TITLE: **USE PERMIT NO. 150**, requested by Eiger Corporation, for 284,300 sq. ft. of commercial and retail floor area with associated waiver requests, on property generally located southeast of the intersection of South 84th Street and Highway 2.

LINCOLN CITY/LANCASTER COUNTY PLANNING STAFF REPORT

P.A.S.: Annexation #03002
Change of Zone #3411 from AG and AGR to H-4 and B-5
Special Permit #2046 for Planned Service Commercial in H-4
Use Permit #150

PROPOSAL: **To allow 357,500 square feet of commercial and retail floor area (284,300 square feet on eight lots in B-5; 73,200 square feet on five lots in H-4).**

**APPIAN WAY REGIONAL CENTER
PHASE II**

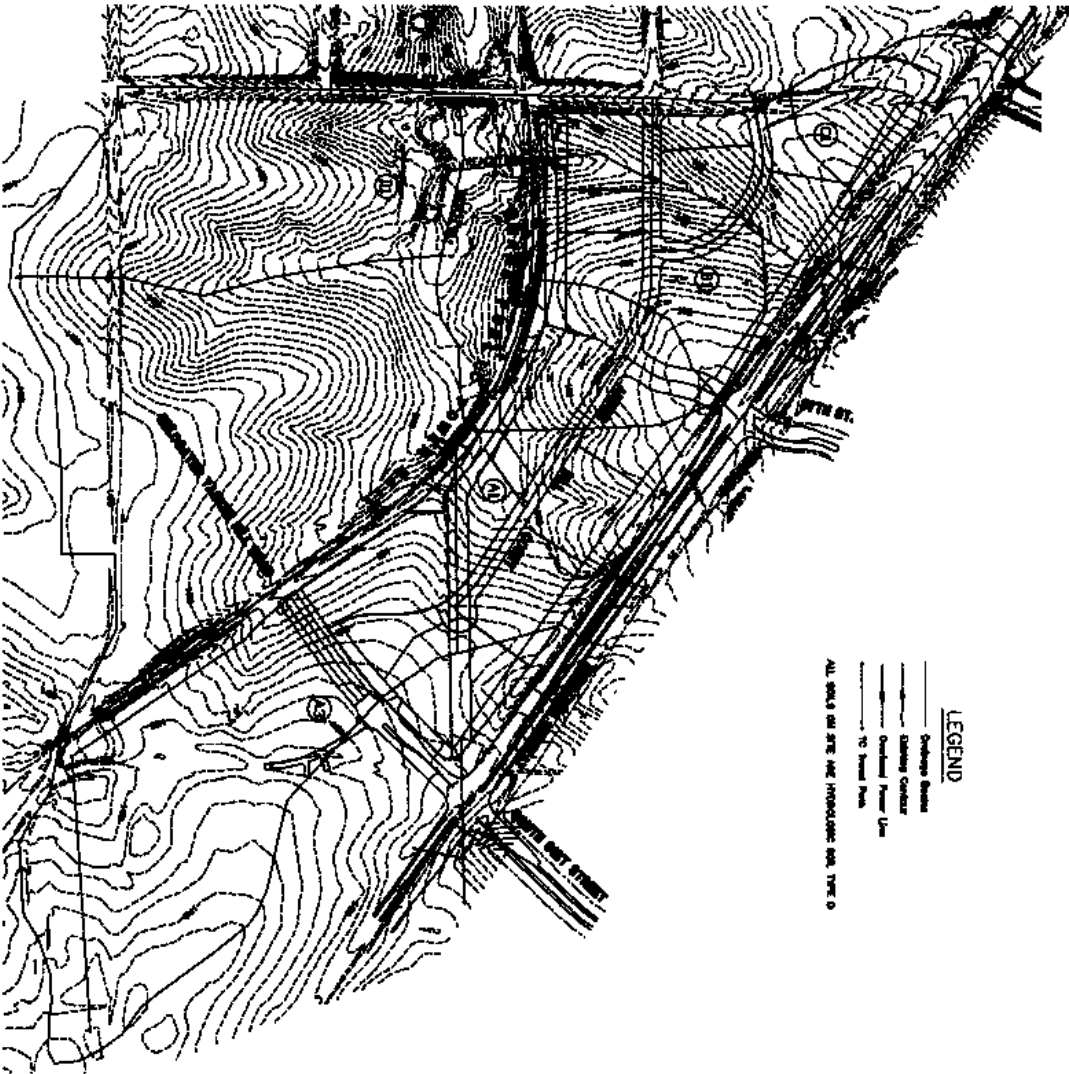
- 1.1.11 The text on Sheet 1 of 7 identifying the setbacks along Highway 2 and South 91st Street amended to state “175' Setback to Buildings and Parking”, and “50' Setback to Buildings and Parking”.

- 1.1.12 Note #13 on Sheet 1 of 7 revised to apply to only the B-5 district.
- ~~1.1.13 A 50' setback in Outlot A from the back of curb along both sides of South 87th Street, subject to more specific language approved by the Director of Planning for clarity. **(**Per Planning Commission, at the request of the applicant and further amended at the request of staff, 01/07/04**)**~~
